S16 PLANNING APPLICATION
APPROVED TONG YAN SAN TSUEN OZP NO. S/YL-TYST/14

**Section 16 Planning Application for Proposed Minor Relaxation of
Building Height and Plot Ratio Restrictions
for Permitted Public Housing Development at
Long Bin, Yuen Long
(Application no. A/YL-TYST/1285)**

Reference is made to the captioned Section 16 application received by the Town Planning Board on 27.9.2024 and the comments received from Planning Department dated 15.10.2024, 24.10.2024, 30.10.2024, 31.10.2024, 4.11.2024, 6.11.2024 and 13.11.2024. We submit herewith the table summarizing HD's responses to the comments as well as the replacement pages and illustrative drawings to substantiate the application.

Drawing title
**PROPOSED AND EXISTING
SEWERAGE SYSTEM**

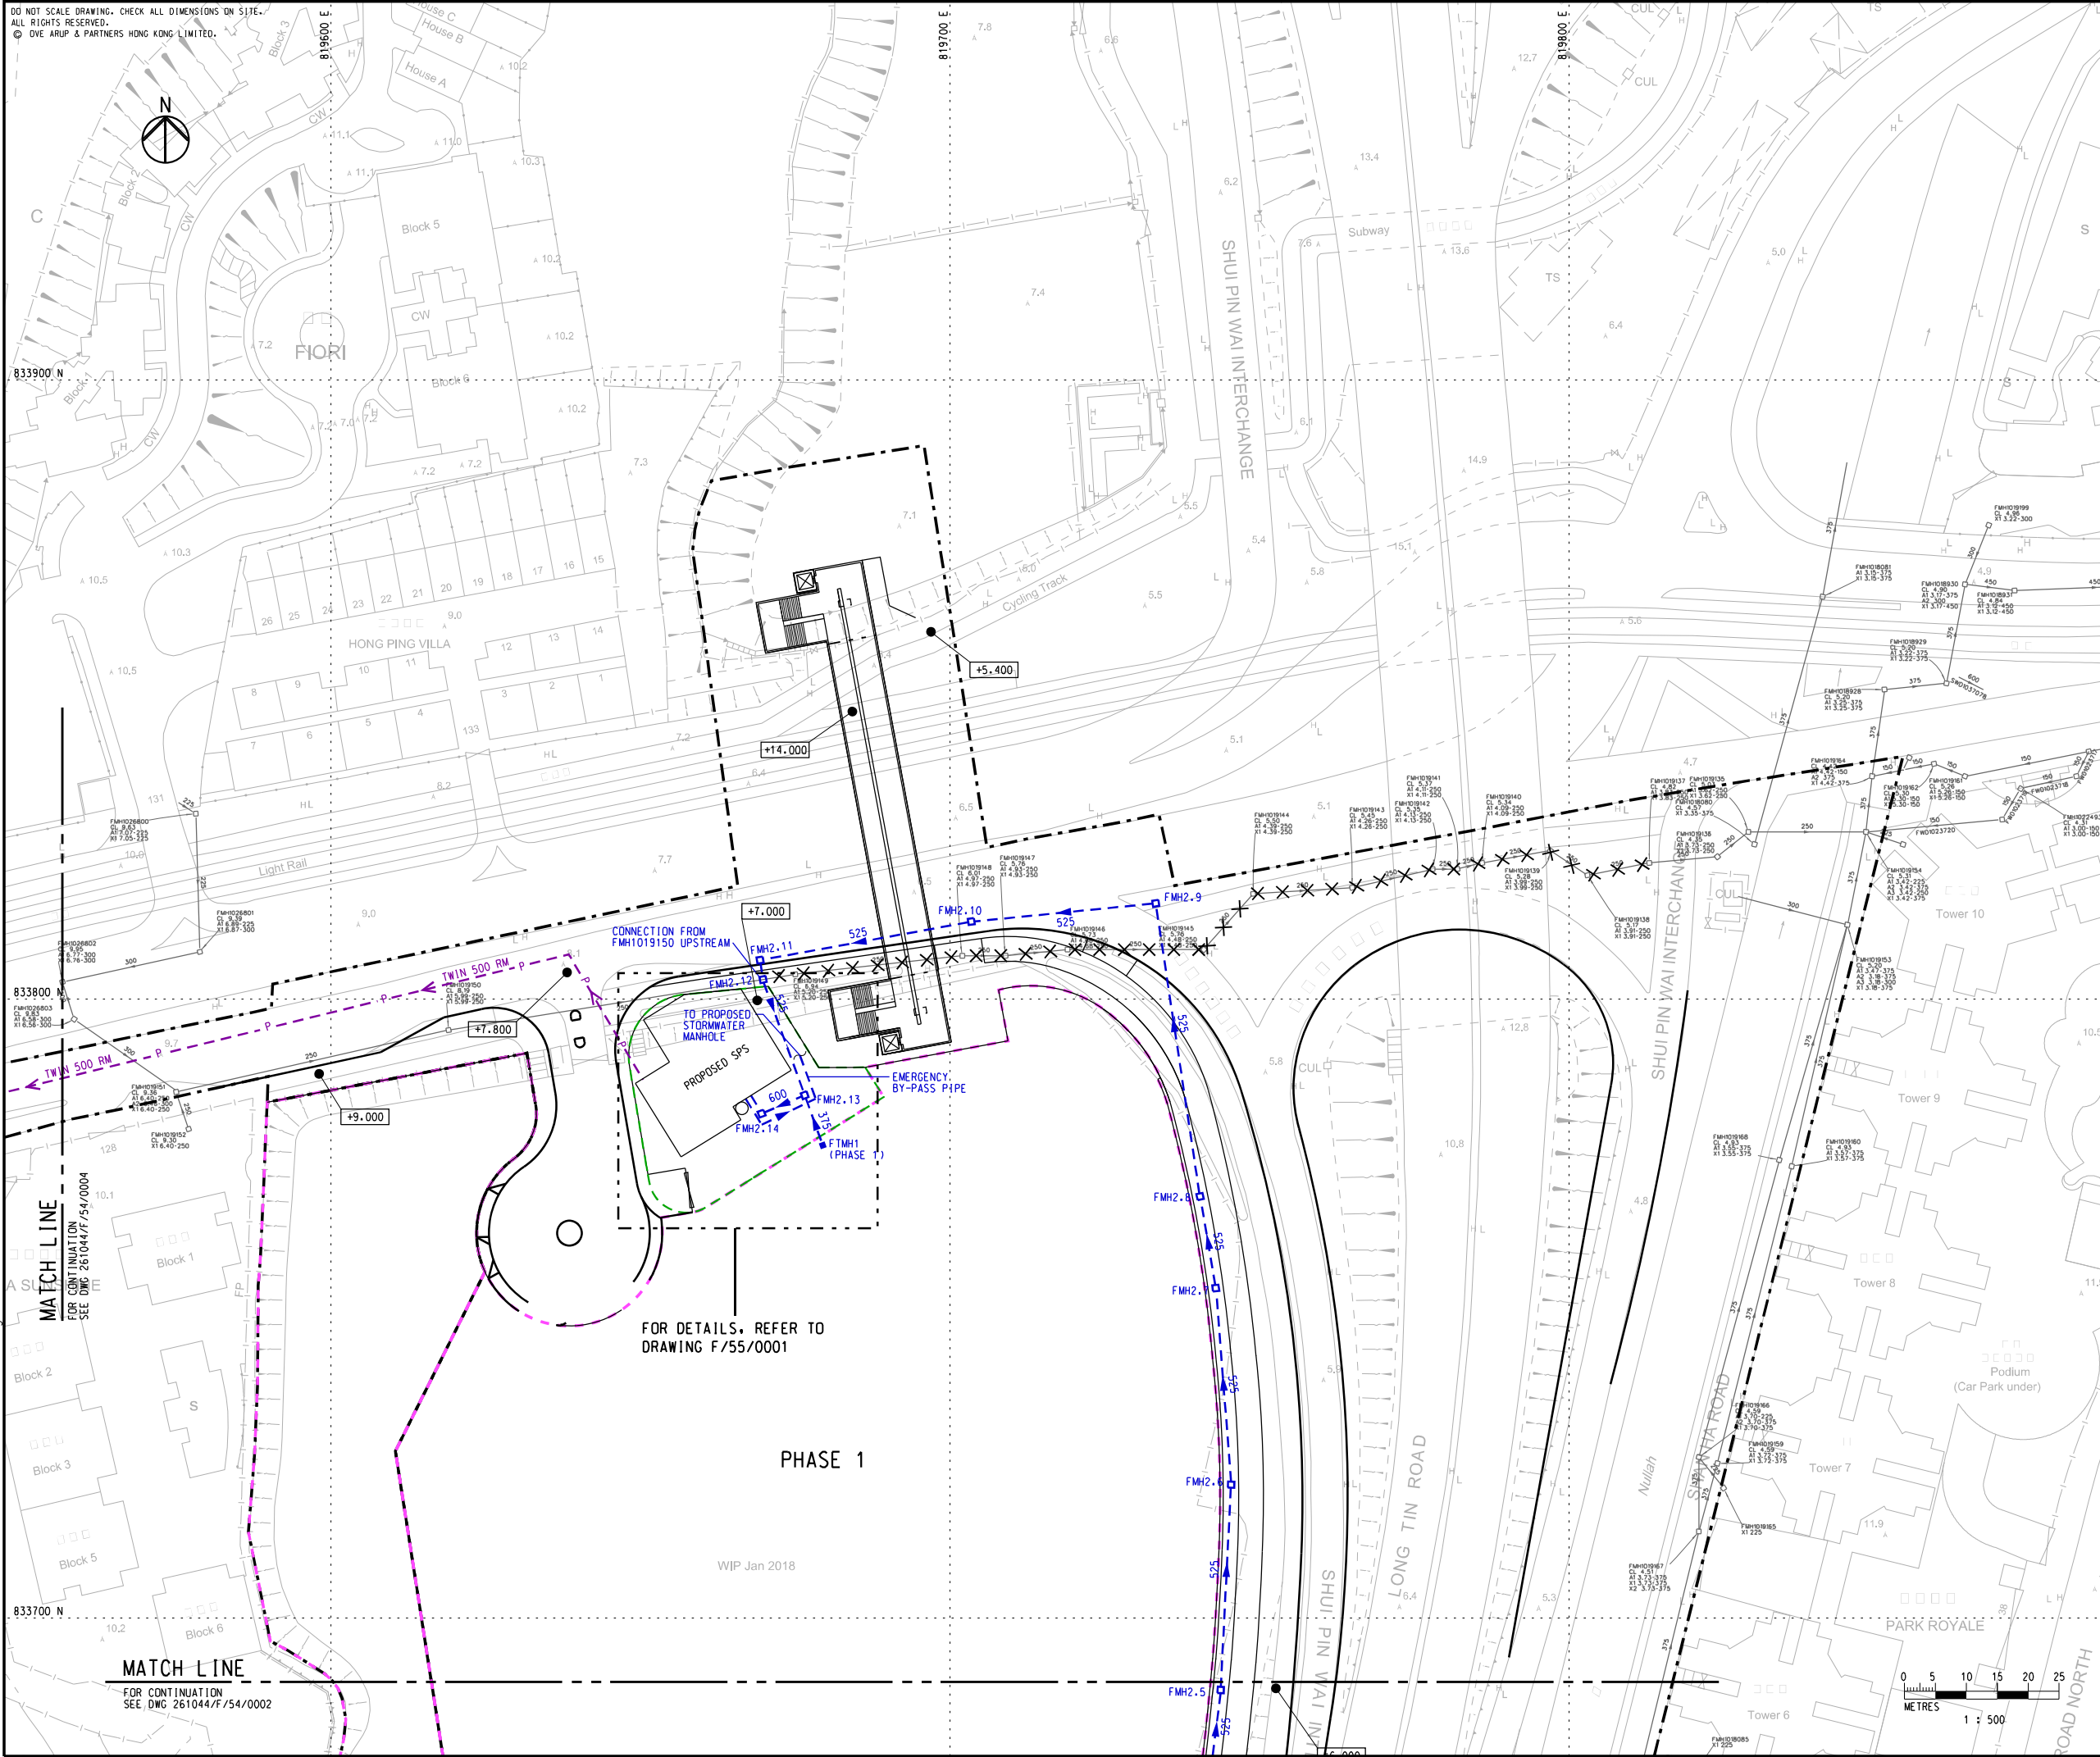
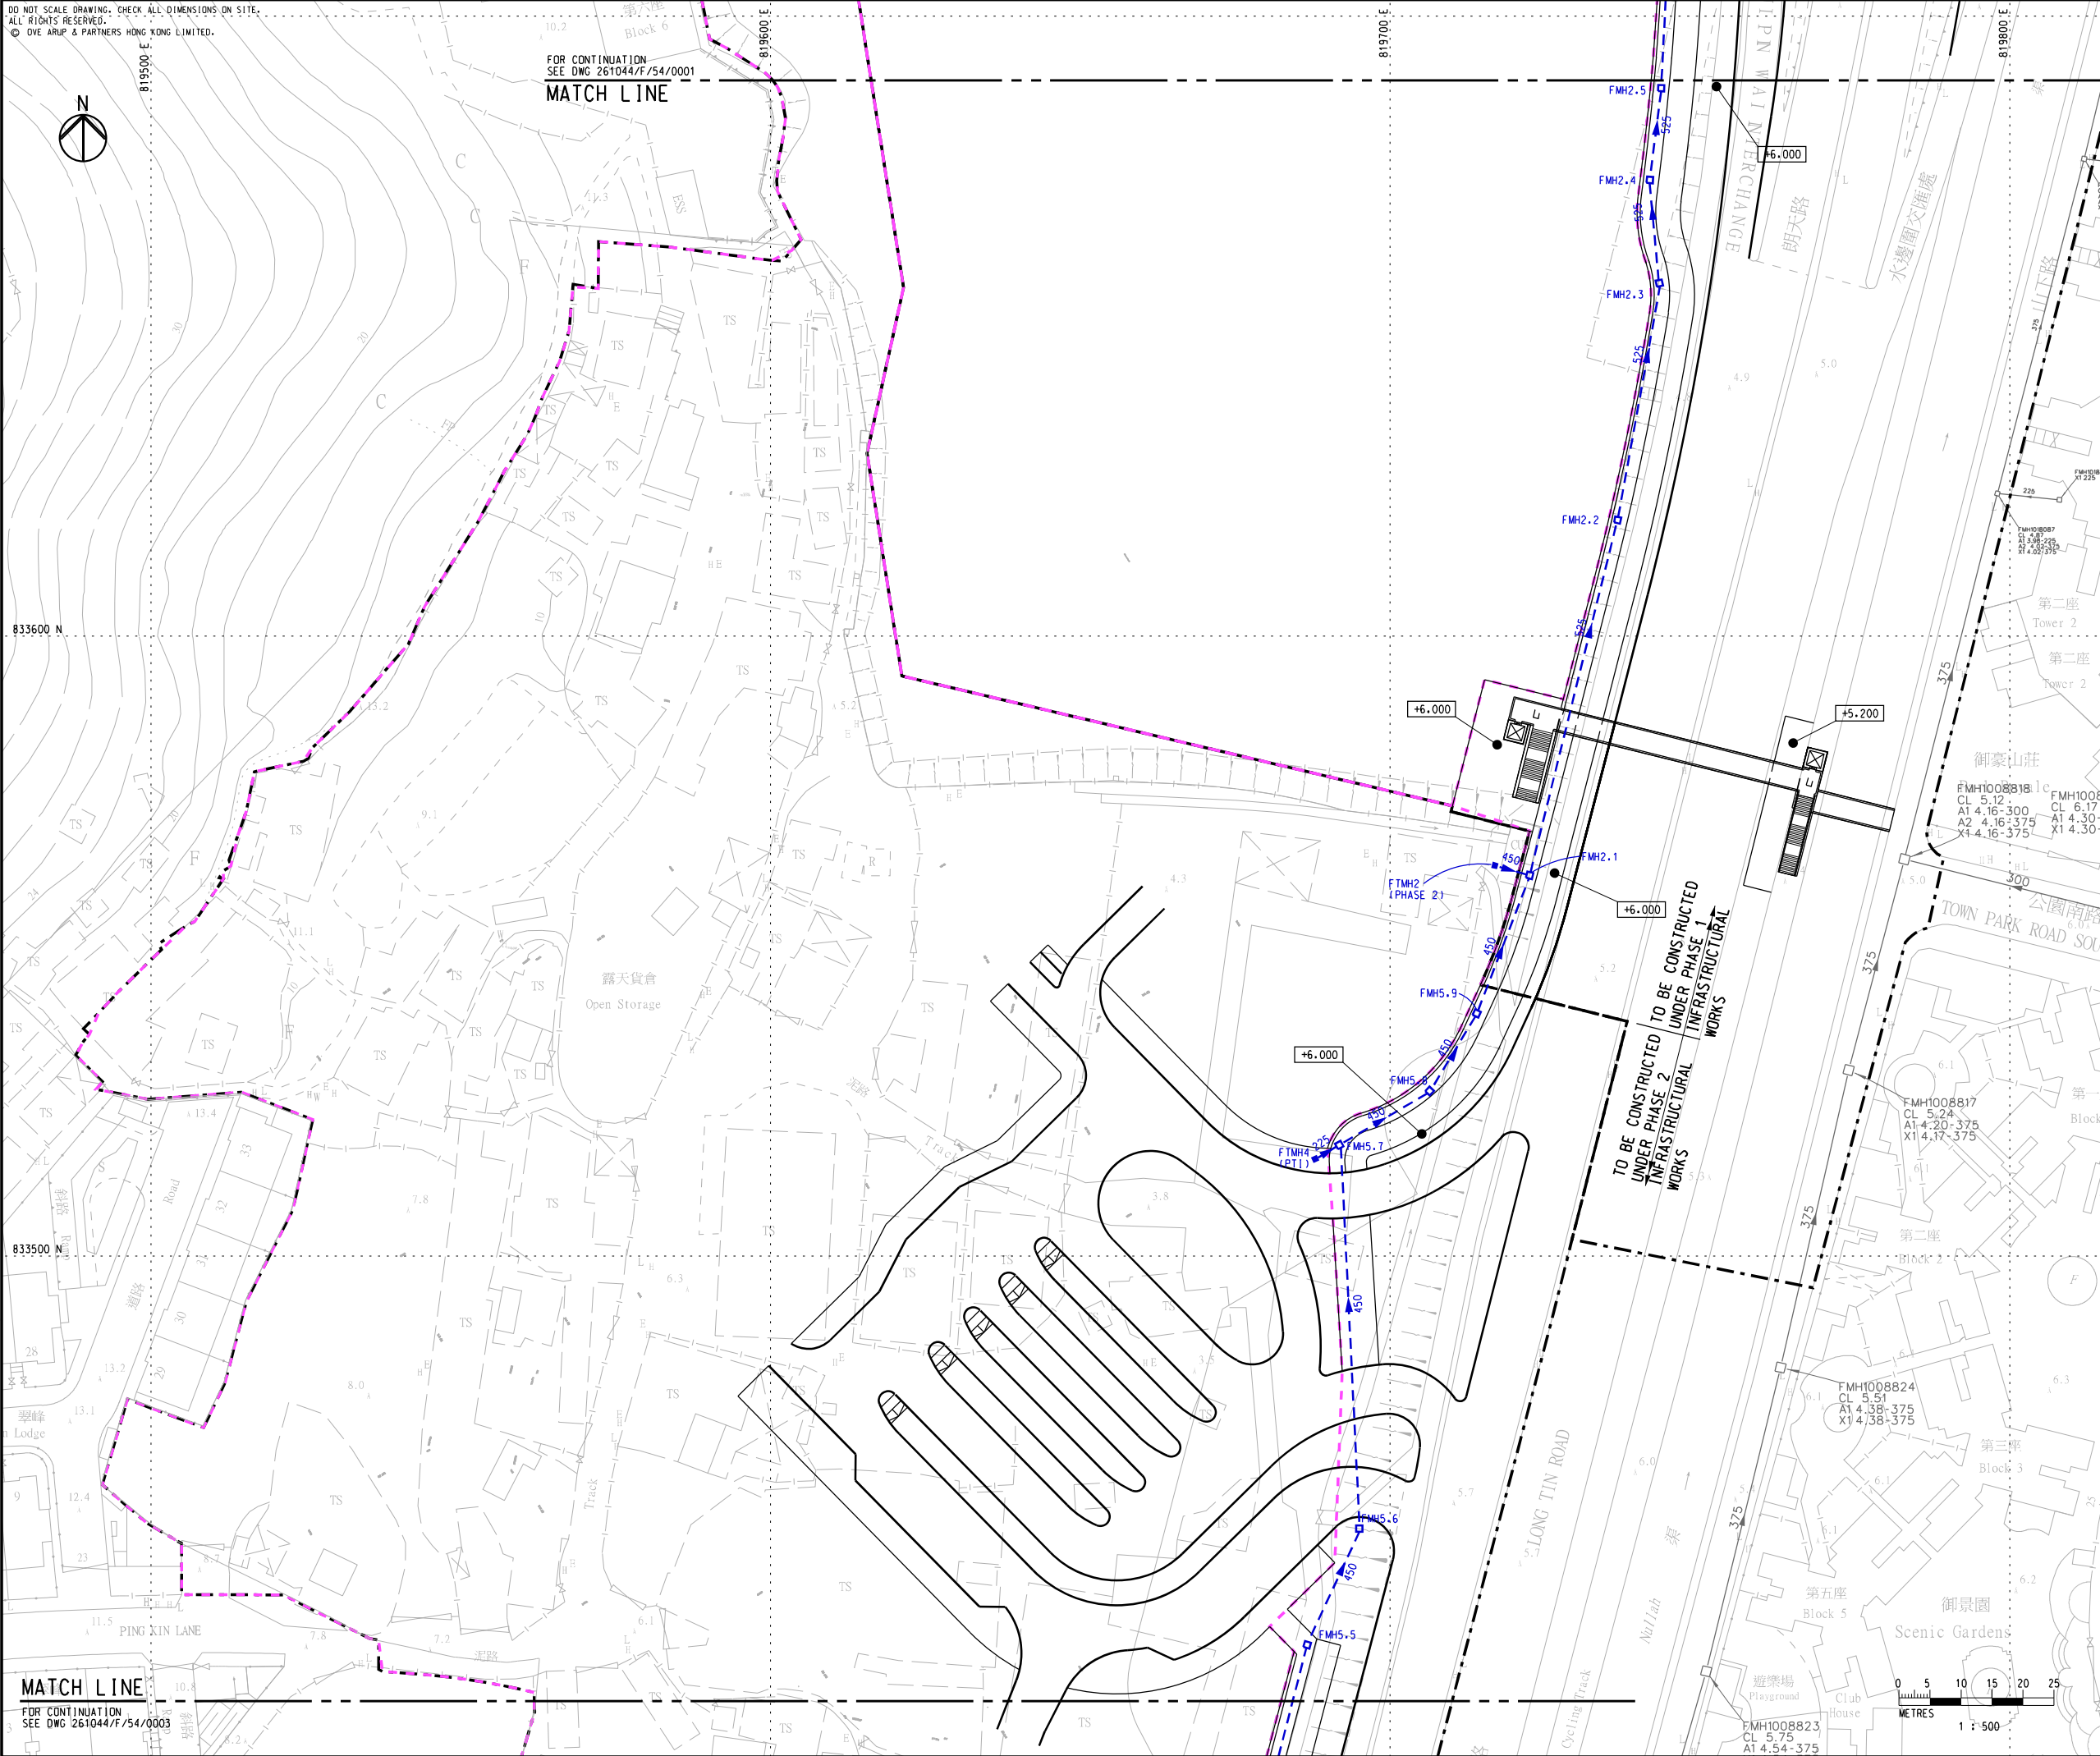
Comments	Responses
	<p><u>Sewerage Impact Assessment (SIA)</u></p> <p>(d) Appendix A – Please provide a plan showing the sewerage discharge path from the application site and the proposed sewerage system for review. The applicant should also check and ensure the hydraulic capacity of the existing sewerage facilities would not be adversely affected by the captioned development.</p>	<p>As elaborated in the Review of SIA, there is only a slight increase of Average Dry Weather Flow (ADWF) 27 m³/day due to the change of development parameters, which constitutes around 0.4% additional total ADWF of Phase 1, 2 & 3 than that determined in the approved Final SIA Report under CE 75/2017 (CE). The impact due to the change of development parameters is therefore considered negligible.</p> <p>The plans showing the sewerage discharged path (as extracted from CEDD's approved Final SIA Report (REP-010-02)) are attached in Attachment 3 which show the proposed sewers constructed along Long Tin Road and connected to a proposed sewage pumping station.</p> <p>The Review of SIA has demonstrated that the hydraulic capacity of the existing sewerage facilities would not be adversely affected by the captioned development.</p>

3. Figure 2: please show the proposed sewer in the layout plan.	Please refer to Attachment 3 for the plans showing the proposed sewers (as extracted from the approved SIA study of CE 75/2017 (CE)).
